10-24 WALGREENS #03606 - SARASOTA,FL

Project Issue Information

Issue Name : EF-4 Dirty and No Airflow

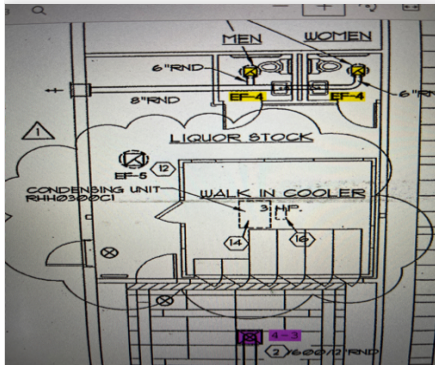
Description : EXISTING EF-4 serving the liquor restroom is running but not exhausting any air from the space. There is a significant buildup of dust and debris in the fan.
